HEAT EXCHANGER RETROFIT KIT INSTRUCTIONS

Kit #'s 550002349, 550002350,
550002351, 550002352

Original heat exchanger for boiler is no longer available, it is replaced by a new block ("J"). Install parts listed to maintain boiler operation.

Figure 1 - Replacement Burner Door with Tabs

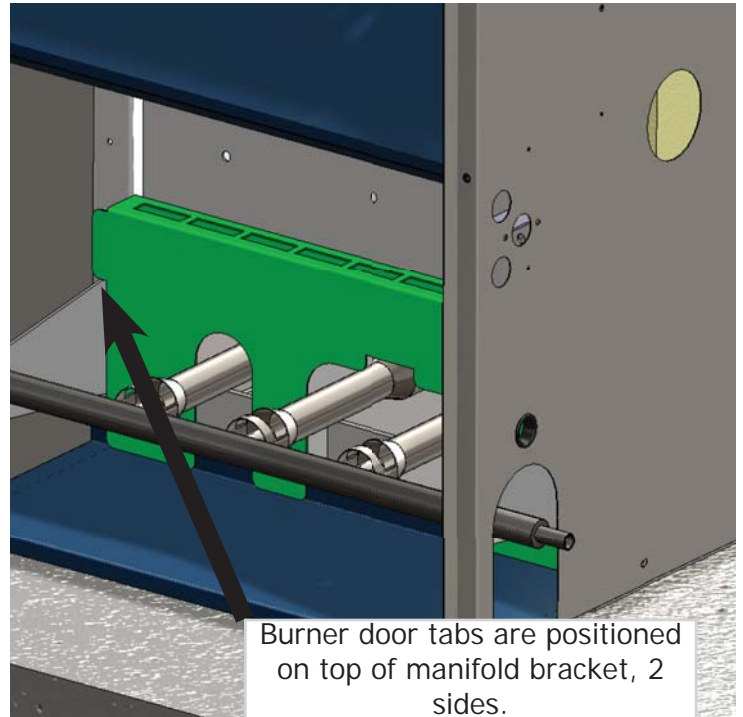
1. Replace Burner Door, Lower Access Panel Door, & Spark Pilot Shield
 - Replacement Burner Door is required on sizes indicated in Table 1.
 - Replacement Base (included) is required on 4 section unit.
 - Discard original burner door to prevent reuse.
2. Relocated Flame Rollout Switch requires relocation with burner door replacement.
 - Label all wires for reference before disassembly.

Figure 3 - Pilot Shield Bracket

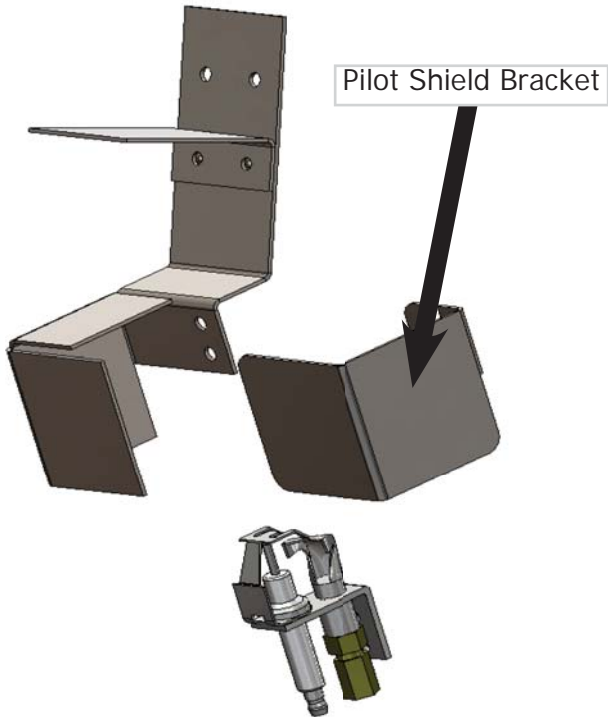
3. Pilot Shielding Bracket on Spark Ignition Models Is Modified with Addition of Temperature Shield. Applies to 4-7 section models.

Figure 4 - Pilot Shield Location

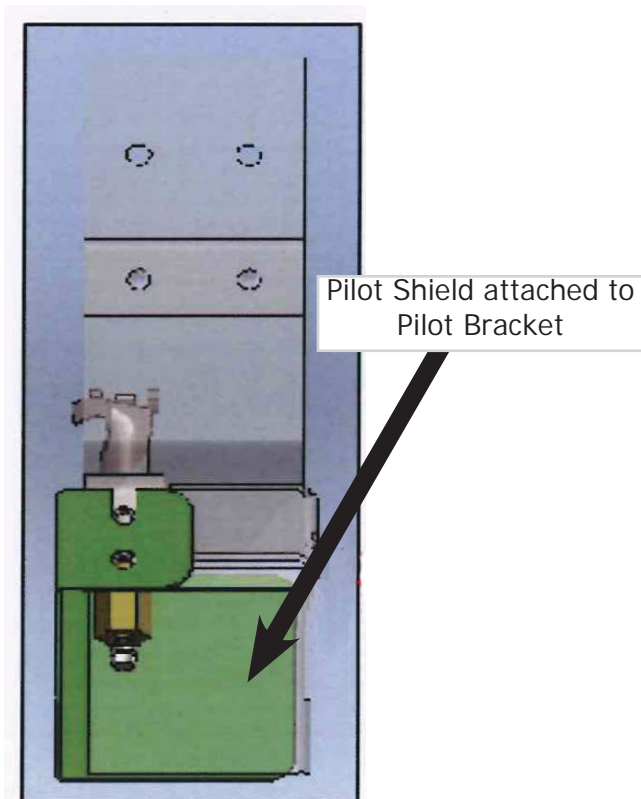
- Attach temperature shield to pilot bracket use same screws used to attach spark igniter. See Figure 4.

Figure 5 - Heat Exchanger

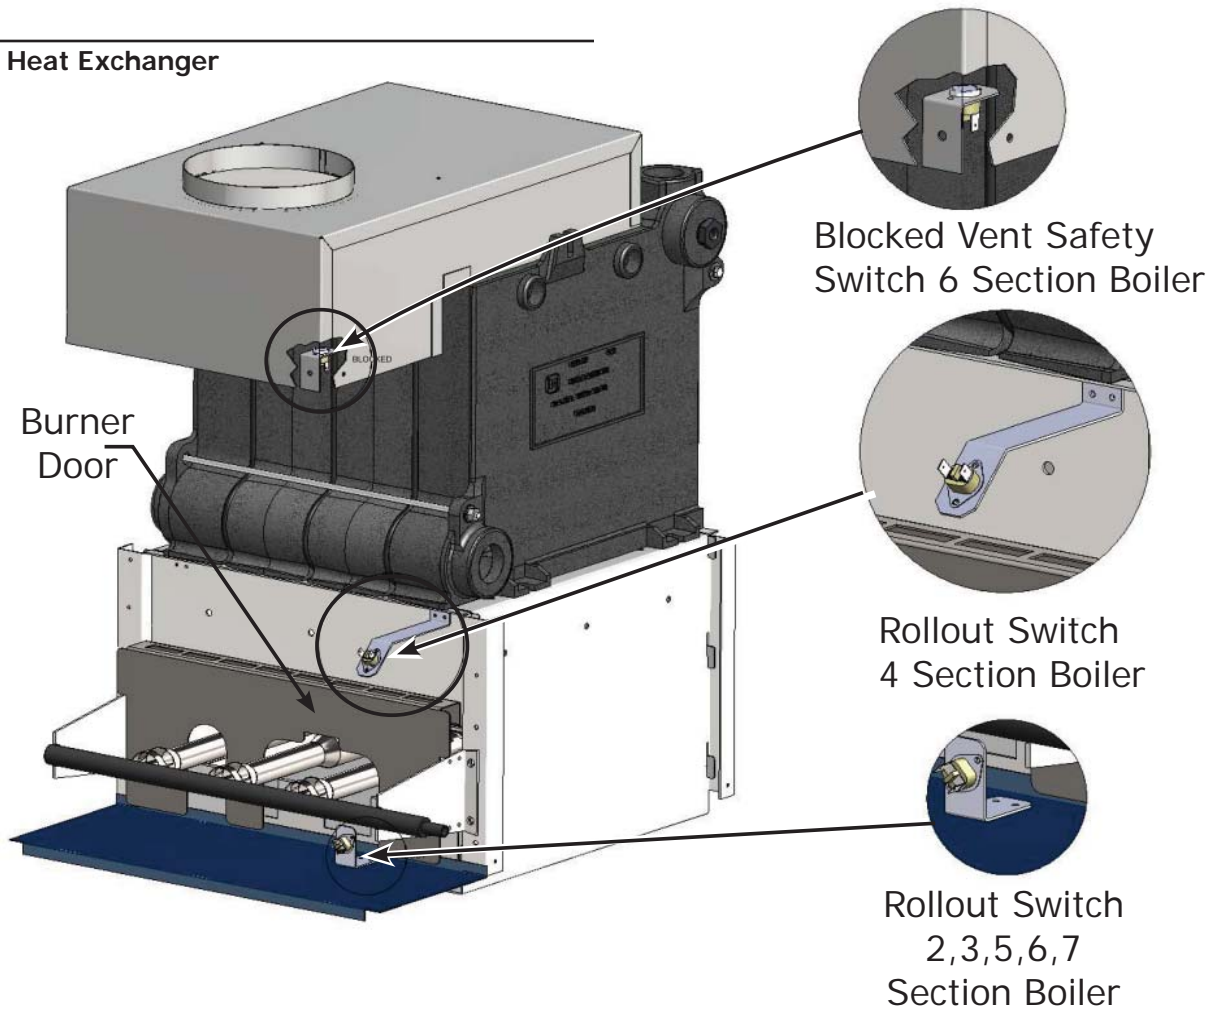
4. Relocation of Blocked Vent Safety Switch (6 Section Boiler only). See Figure 5.
